# FIELD INSPECTION REPORT FOR PRICE RIVER DISTRIBUTION SYSTEM

Prepared by Gertrudys Adkins  
Field Inspection date: July 6, 2004.

PRICE RIVER DISTRIBUTION SYSTEM TOUR OF DIVERSIONS ( 7/6/2004)

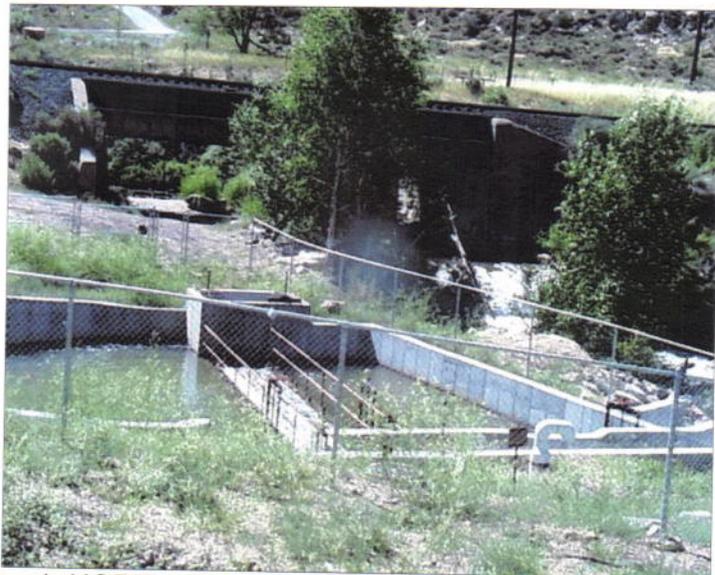
There is a small head gate a few yards below the Price Wellington Diversion structure that diverts water to one of the Golf Course ponds. Picture # 10: Diversion headgate.

2: NORTH CARBON GROUP DIV. HEADGATE

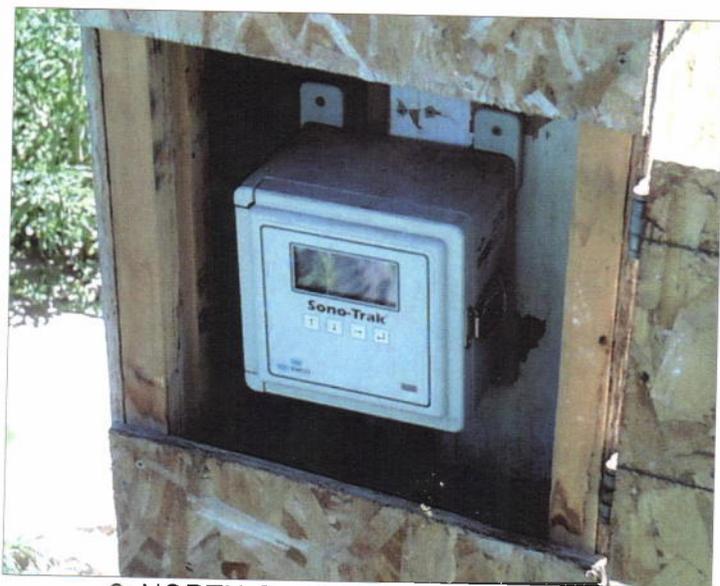
There is a pipeline at this diversion that was recently built and diverts water for the following water users: Spring Glen Canal Company, Bryner Hansen Canal Co., Stowell Ditch, and Oberto Ditch. Bryner Ploutz Canal Company has a separate pipeline that originates at this point. The North Carbon Group has direct flow rights as well as reservoir rights. The pipeline capacity is about half of the combined water rights flows. The pipeline has a 40-inch diameter, which later is reduced to 36 inches. There is a sedimentation pond at this diversion. Water is measured downstream with an Ultrasonic meter. The meter sometimes stops working and thus the totalizer does not indicate all of the usage. Picture #1: Diversion structure and pond. Picture #2: Diversion headgate. Picture #3: Meter.

**Recommendation:** The meter should be maintained regularly to assure proper operation and accuracy.
